# Karanga-a-hape Station Neighbourhood Improvements Project

75 % Detailed Design

Safe System Audit

22 December 2023

**Figure 8: Proposed southbound lane markings on Pitt Street at Pitt / Vincent / Hopetoun**

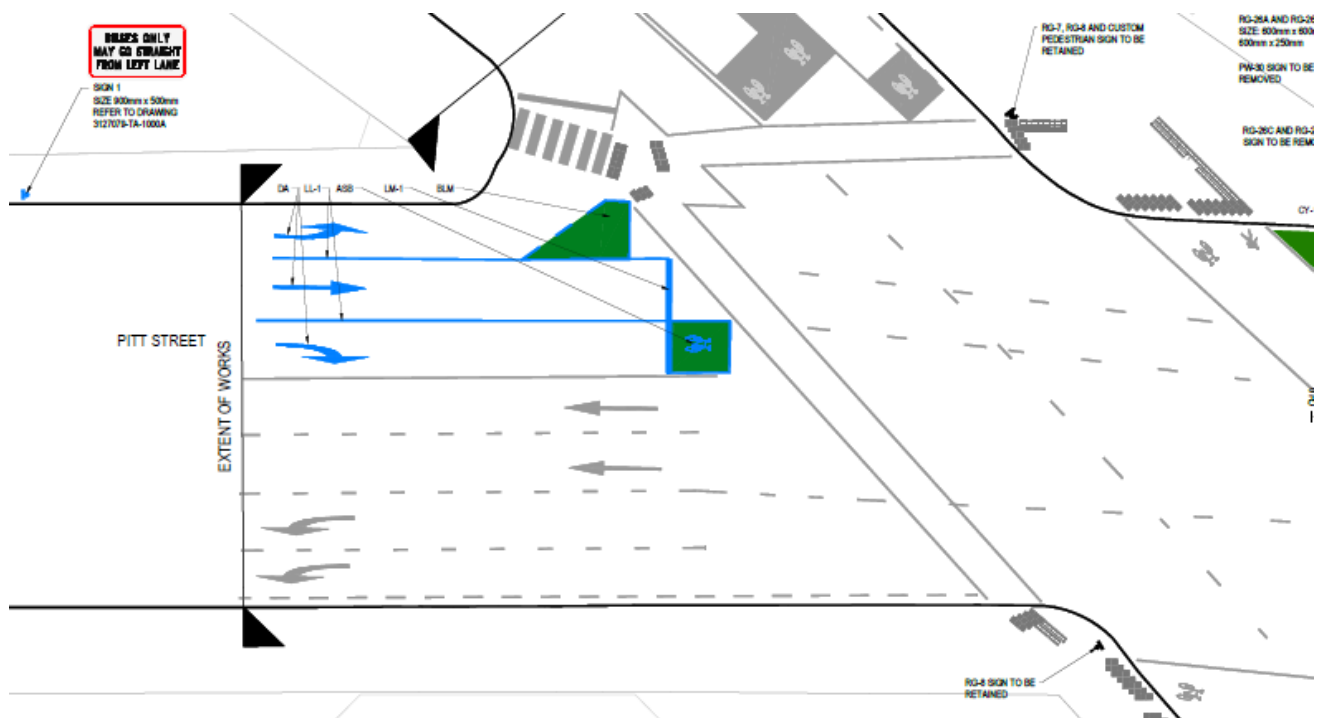
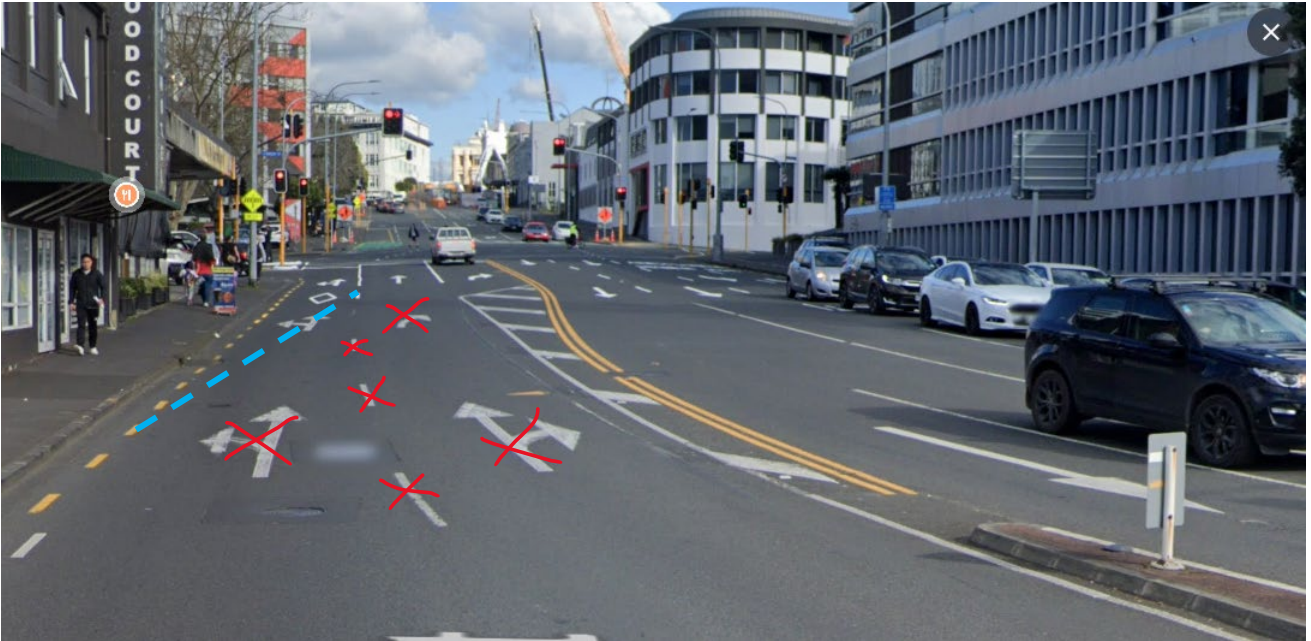
Changes to the southbound lane arrow markings on Pitt Street prior to the intersection with Vincent Street and Hopetoun Street are proposed. This will turn the kerbside lane from a 'through left' to a 'left only' lane.

There are several lane arrow markings prior to the proposed markings that appear to have been overlooked. Refer to Figure 9.

All the southbound lane arrow markings on Pitt Street between Hobson Street and the Vincent / Hopetoun intersection need to be updated to merge the two straight ahead lanes (from Union Street) into one through lane, thereby avoiding the kerbside through lane becoming a trap lane for the left turn into Vincent Street. If these markings are not changed the lane change / sideswipe crashes are likely.

Figure 10: Pitt Street / Poynton Terrace

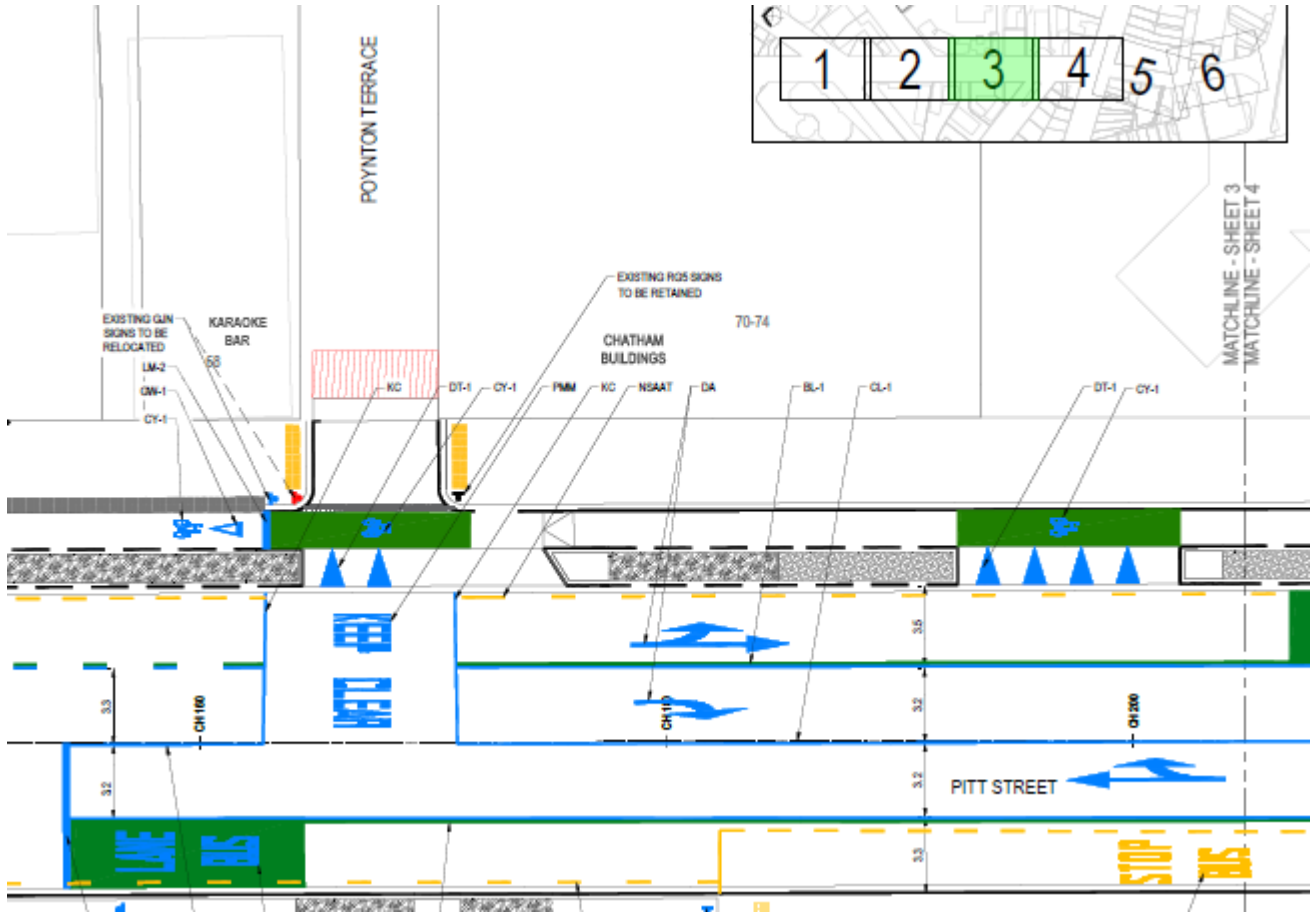
At Poynton Terrace the design has changed (from the Developed Design) and pedestrians and cyclists will now be required to give way to traffic entering and leaving Poynton Terrace. As this is the only side road intersection within the project area which has been treated in this manner (as Greys Avenue has a paired crossing) the need to give way is likely to be overlooked by many pedestrians and cyclists.

A design inconsistency such as this is likely to lead to conflicts between cyclists / pedestrians and vehicles accessing Poynton Terrace with occasional slow speed collisions between the modes.

- 1 Amend the design to provide pedestrian and cyclist right of way over vehicles accessing Poynton Terrace.

Figure 11: Pitt Street signalised pedestrian crossing

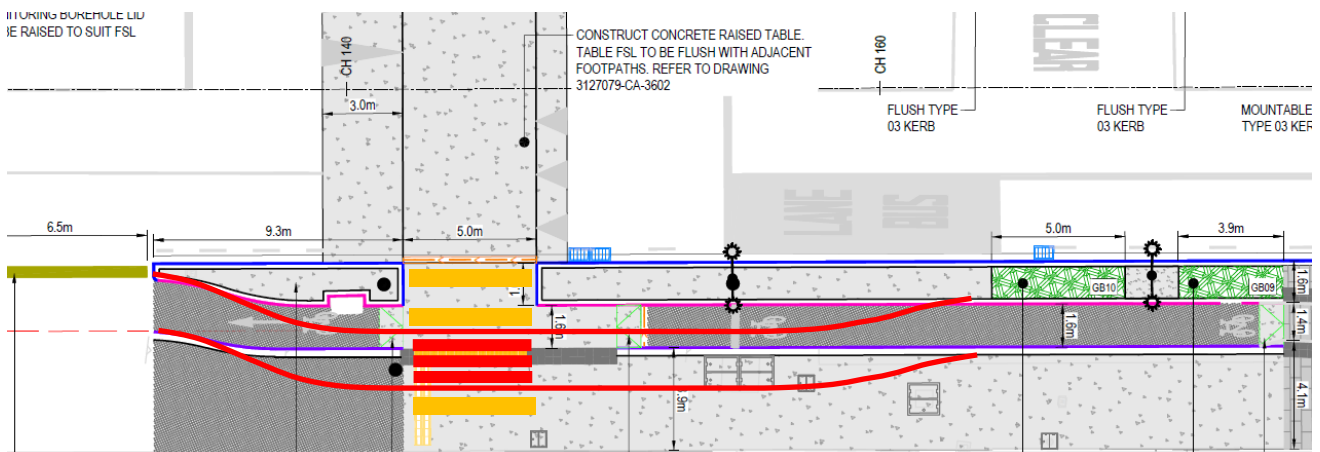
Pedestrians waiting to cross at the proposed Pitt Street mid-block crossing are likely to choose to wait by the kerb line at the road edge, not back at the tactile ground surface indicators behind the cycle path as intended by the designers. Pedestrians will naturally move as close to the edge of the road as possible and this behaviour was observed in Karangahape Road, and in one case was observed to result in a near miss between pedestrians and a passing e-scooter. This concern is also discussed in Section 5.4 (and shown in Figure 17 and Figure 19).

This places pedestrians in conflict with cyclists on Pitt Street who will assume they have priority through the crossing when the road signal is green (as presumably they will only be held on a red signal when the crossing is operating).

Given the berm at the road edge is 1.6 m wide there would appear to be enough space to place a push button at the road edge and allow pedestrians to wait where they will naturally choose to. If additional waiting area is a concern, then the design could be modified to provide a larger waiting area as suggested in Figure 11. The additional benefit of this amendment would mean that pedestrians cyclists would be able to ride through this area at all times, only having to stop for pedestrians when they cross the zebra crossing.

**Figure 18: Proposed arrangement at Karangahape Road / Pitt Street**

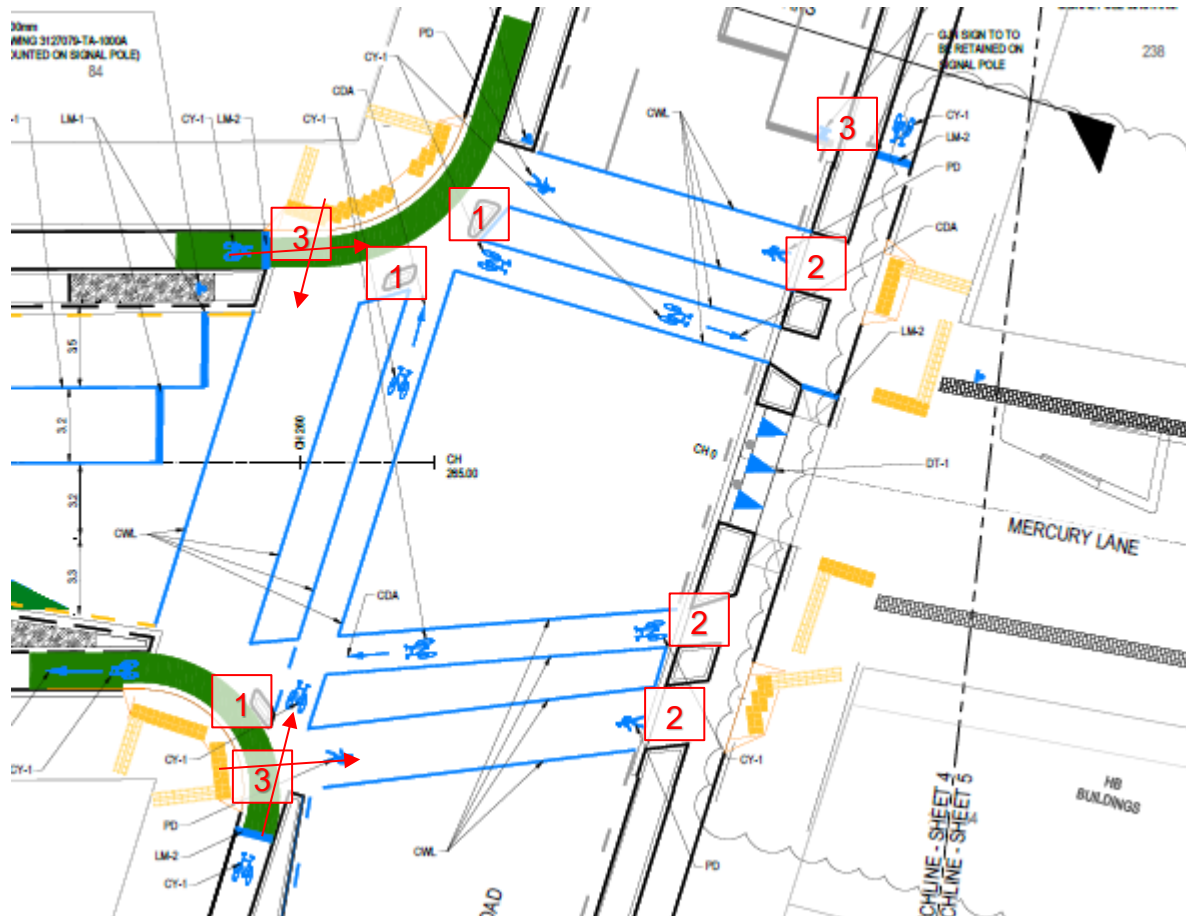
Section 5.1.1 of the Developed Design SSA (3 July 2023) discussed several concerns with the proposed arrangement of the signalised pedestrian and cyclist crossings at the intersection of Pitt Street and Karangahape Road. This primarily related to the confusing hybridised way the footpaths and cycleways were to be arranged in each corner.

The safety concerns raised in the developed design SSA do not appear to have been considered in the designer team's response to that audit or the close-out process, so have been reproduced in this report for further consideration.

In summary, the proposed arrangement will create confusion regarding the correct place to call and wait for a crossing display and has not taken human behaviour into account. The confusion will not only place pedestrians and cyclists in conflict with one another but may also lead to pedestrians and cyclists waiting within the intersection, possibly leading to conflicts with turning vehicles, especially when there are dozens of pedestrians crowding at the crossings. The contributing factors are listed below.

- c. Assuming the Barnes dance signal phase will remain, cyclists are likely to want to cross with pedestrians on seeing the display change to green. The safety concern with that type of operation (if allowed) is that many of the cyclists will be waiting perpendicular to pedestrians who are crossing in a different direction (e.g., southbound cyclists on Pitt Street waiting to cross to Mercury Lane will be setting off in direct conflict with westbound pedestrians on the southern side of Karangahape Road waiting to cross Pitt Street).

Figure 20: An alternative fully separated pedestrian and cyclist layout

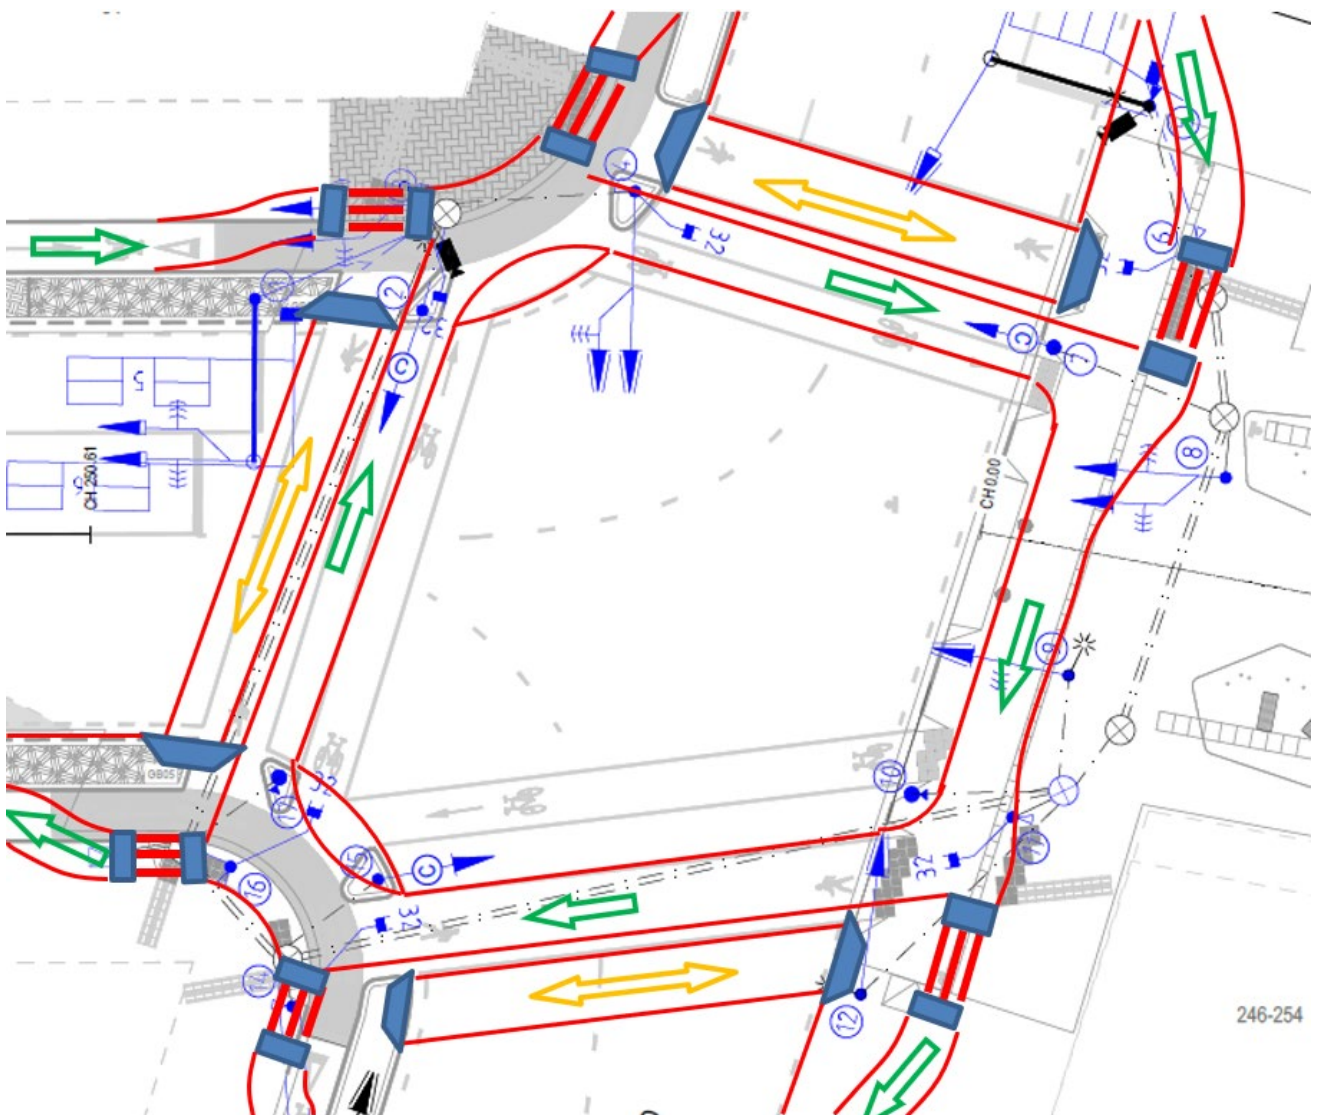
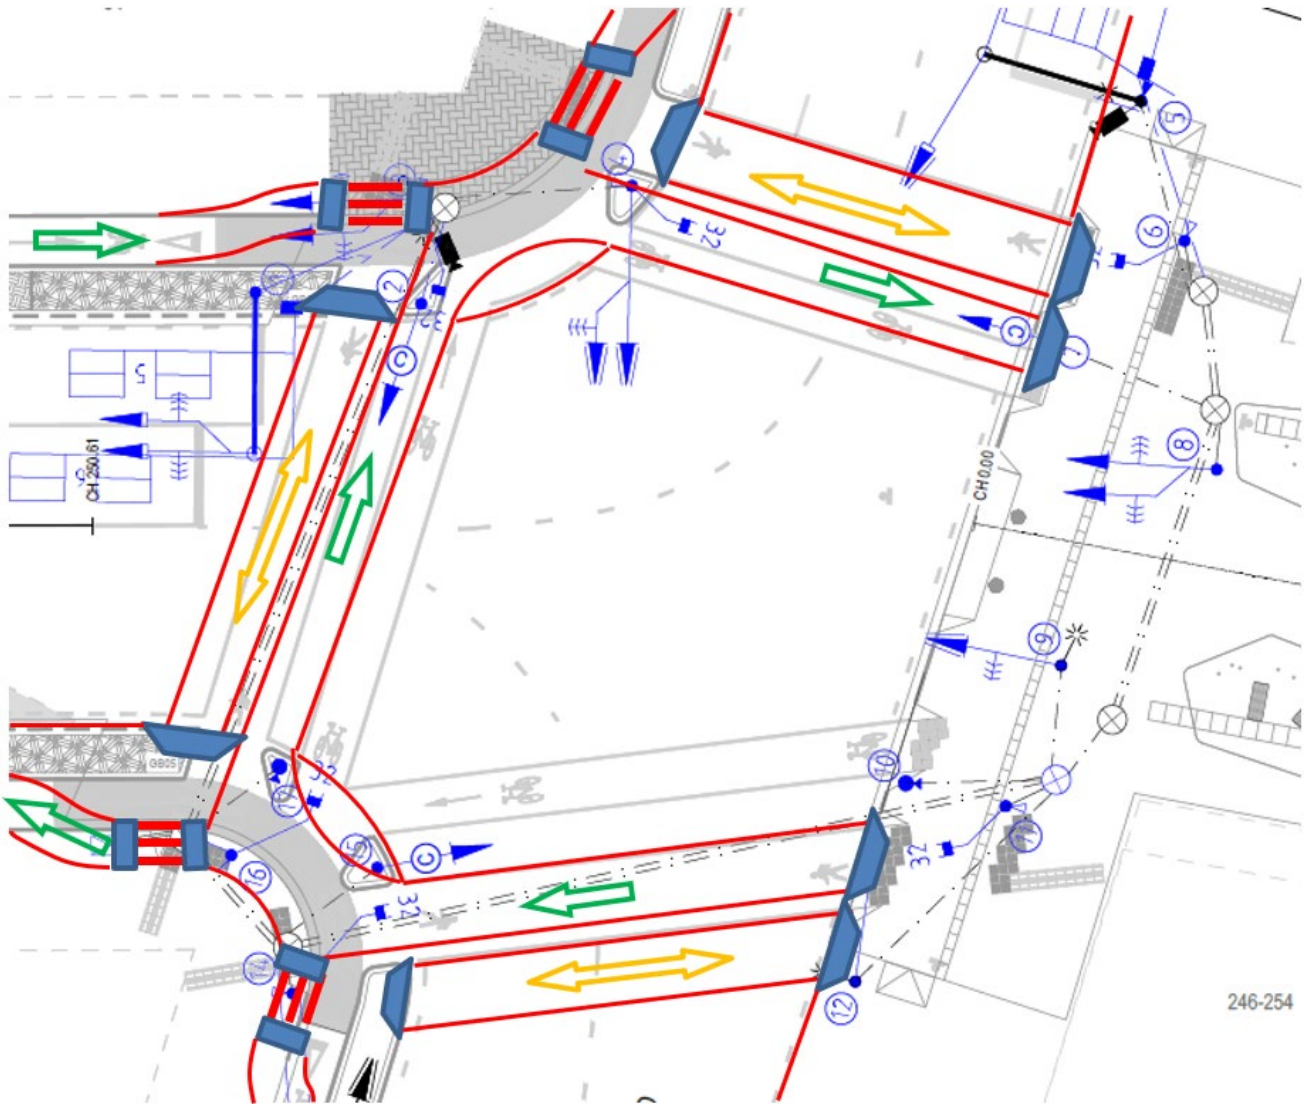
Another option, if separation of facilities through the intersection of Pitt Street and Karangahape Road is desired, is to assign priority very clearly at each conflict point. Layouts within the space available are suggested in Figure 20 and Figure 21.

It should be noted that a Barnes dance is not the safest or necessarily the most efficient phasing for the formalised layouts indicated in the proposed layout in Figure 18 or in the suggested alternative formalised layouts in Figure 20 and Figure 21. It should also be noted a Barnes dance phasing of the signals will result in some pedestrians and cyclists crossing diagonally and thus the proposed layout of crosswalk lines and one-way cycle crossings may not be used as intended.

- 1 If mode separation is required, then consider adopting a layout like Figure 20 or Figure 21 which minimises conflicts between pedestrians and cyclists using the cycleways and clarifies who has priority in each waiting areas.

Figure 22: Examples of proposed cycle lane markings

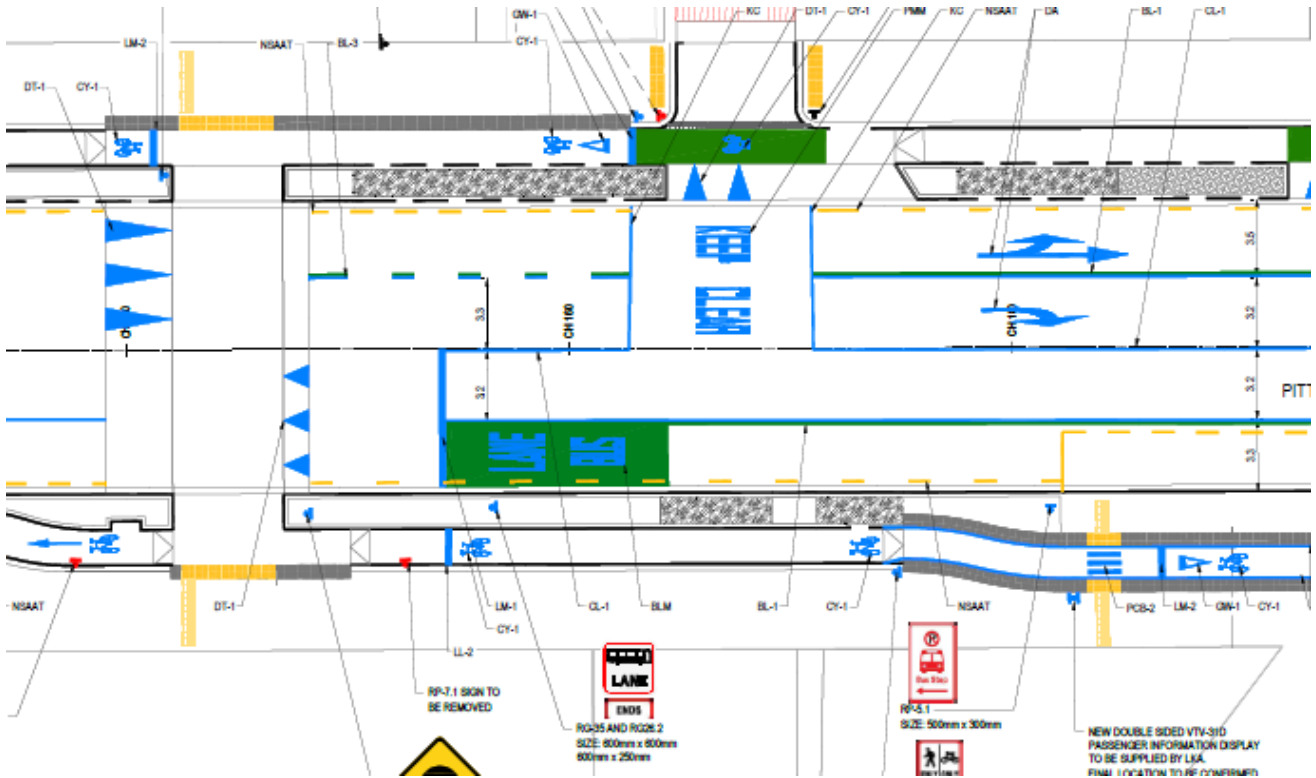
In several cases the markings proposed for the cycle path are not technically correct, or they have not been applied in way that adds significant value. For example

- Give way triangle markings have been proposed in advance of zebra crossings.
- Where give way triangle markings have been correctly located, they technically require an associated give way sign to be legalised. Refer to section 10.3(1) of the Traffic Control Devices Rule – for an intersection to be give way controlled a give way sign must be installed along with the triangle marking, unless the road surface makes the application of the road marking impractical.

- Many cycle symbols have been placed without arrows.
- Where cycle path arrows have been proposed they have been applied downstream from conflict points to reinforce to cyclists that they are going the correct way, rather than upstream of the conflict location to send a message that cyclists might be heading the wrong way. Arrows should be placed at all potential entry points, so cyclists don't make an incorrect decision and ride the wrong way on the cycle path.

Figure 23: Option 1

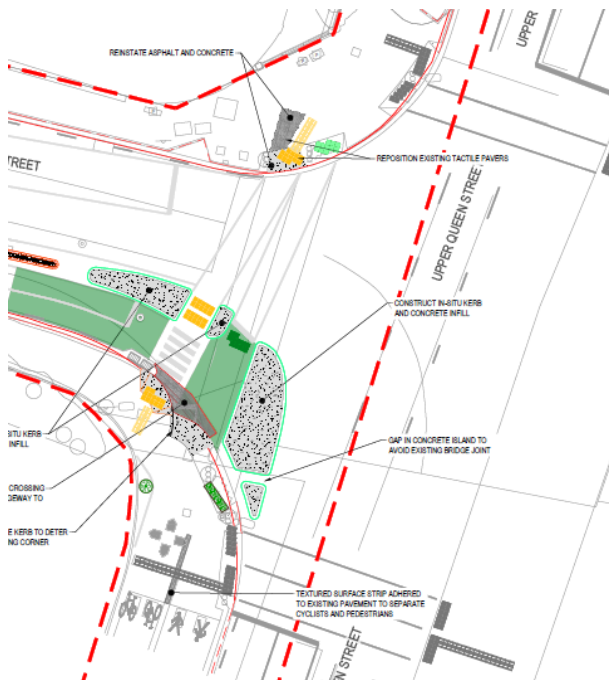
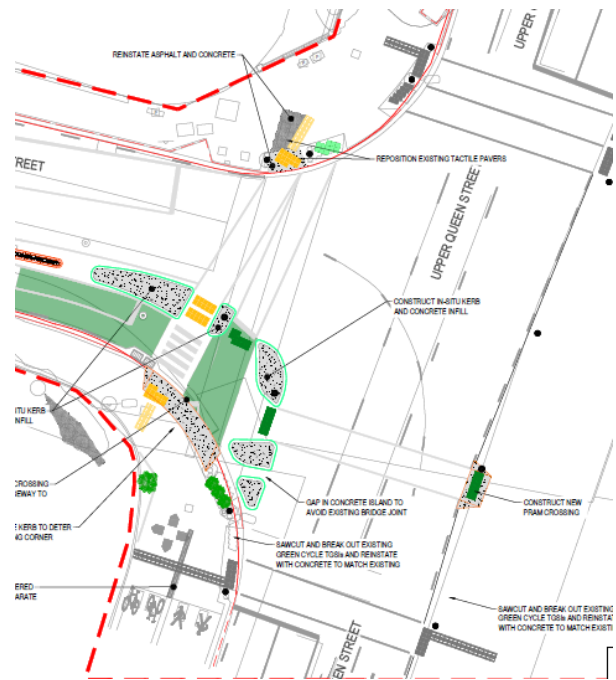
Two options for the connection between the Canada Street cycleway and the existing Grafton Gully cycleway, Upper Queen Street cycleways are shown in Figure 23 and Figure 24.

Both options are a significant improvement on the layout proposed in the developed design and will help mitigate the concerns raised in the developed design audit. From a safe system perspective, the Option 2 layout would provide a safer alignment for cyclists, as the separated cycle crossing would reduce the number of conflict points and provide greater separation area between pedestrians and cyclists.

- 1 Adopt the Option 2 (Sheet 9) layout.
